## **Groundwater Transfer Review Summary Form**

Transfer/PA # T- <u>14536</u>					
GW Reviewer A. Wentworth Date Review Completed: <u>12/17/2024</u>					
Summary of Same Source Review:					
☐ The proposed change in point of appropriation is not within the same aquifer as per OAR 690-380-2110(2).					
Summary of Injury Review:					
$\Box$ The proposed transfer will result in another, existing water right not receiving previously available water to which it is legally entitled or result in significant interference with a surface water source as pe 690-380-0100(3).					
Summary of GW-SW Transfer Similarity Review:					
☐ The proposed SW-GW transfer doesn't meet the definition of "similarly" as per OAR 690-380-2130.					
This is only a summary. Documentation is attached and should be read thoroughly to understand the basis for determinations.

Other				
1.	Basic description of the changes proposed in this transfer: The applicant proposes to temporarily add an additional point of appropriation to Certificate 55015 in order to prevent 5 years of non-use. The authorized and proposed POAs associated with these water rights are displayed in Table 1.  Table 1:				
	Certificate	Authorized PO

Figure 1. Map of Authorized POA, Proposed APOA, and nearest groundwater right POAs

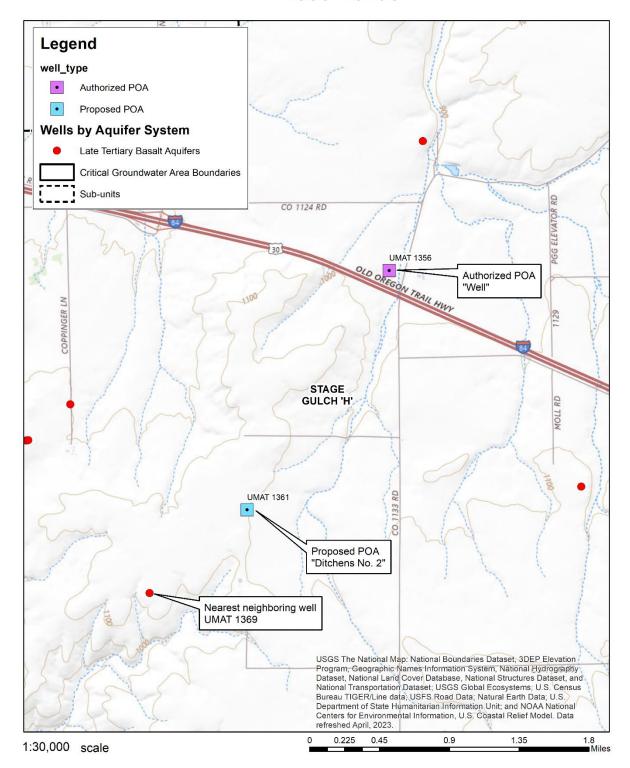
2.	Will the proposed POA develop the same aquifer (source) as the existing authorized POA?  Yes Do Comments: All Authorized and Proposed POAs produce water from the Columbia River Basalt aquifers in the Stage Gulch Critical Groundwater Area, Subarea H.

Figure 2. Estimated interference drawdown at the nearest neighboring well resulting from pumping under Certificate 55015 at the Authorized POA UMAT 1356.

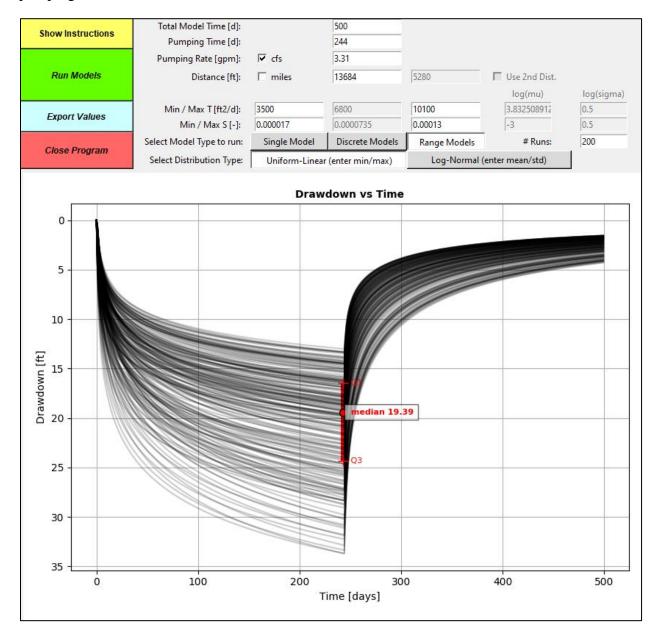
4.	a) Will this proposed change, at its maximum allowed rate of use, likely result in an increase in interference with <b>another groundwater right</b> ?			
	Yes ☐ No Comments: The nearest groundwater right POA to the Proposed APOA is UMAT 1369, which is located 4,375 feet to the southwest. Pumping at the combined maximum rates for the proposed APOA—Certificate 55015 (3.31 cfs) and the currently authorized groundwater rights: Cert 87713 (1.57 cfs), Cert 84095 (1.47 cfs), T-10517 (2.2 cfs + 0.68 cfs + 2.91 cfs = 5.79 cfs)—will likely result in increased interference (Figure 2 and Figure 3).

b) If yes, would this proposed change, at its maximum allowed rate of use, likely result in another groundwater right not receiving the water to which it is legally entitled?			
	☐ Yes ☒ No If yes, explain: <u>Interference at the closest groundwater right POA from pumping at the Authorized POA (UMAT 1356) is 19.39 feet, compared to 27.08 feet from Proposed APOA (UMAT 1361).</u>
